# Access Compliance Report

## Public Rights-of-Way

### (Curb Ramps)

Intersection ID: 9658	Main Street: VANDERBILT_RD	Cross Street: WOODWARD_AV	Location: NW
ADA ID: 663B862EC420	Ramp Type: Para	Initial Pass/Fail: Fail	Overall Compliance: No
Codes/Mitigation Info/Possible Solution		Field Measurements/Component Compliance	
Severity Score: 37.5

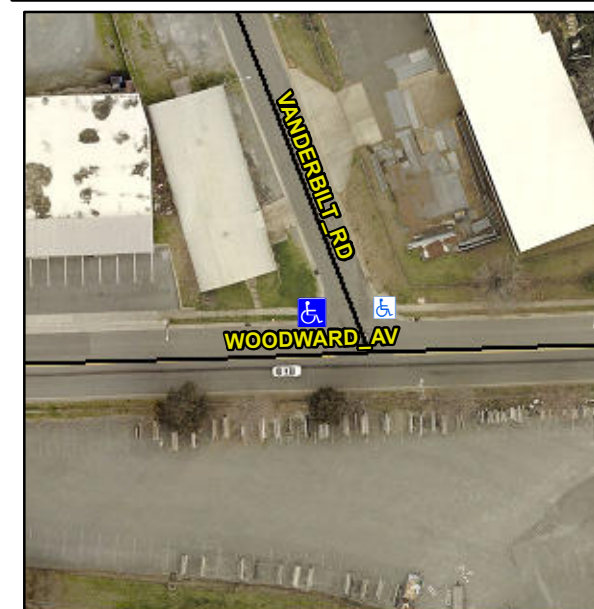
**CURB GAP 1.0, LT RP < 5%**

**R304.5.3, R304.3.2**

**Remove & Replace Entire Ramp.**
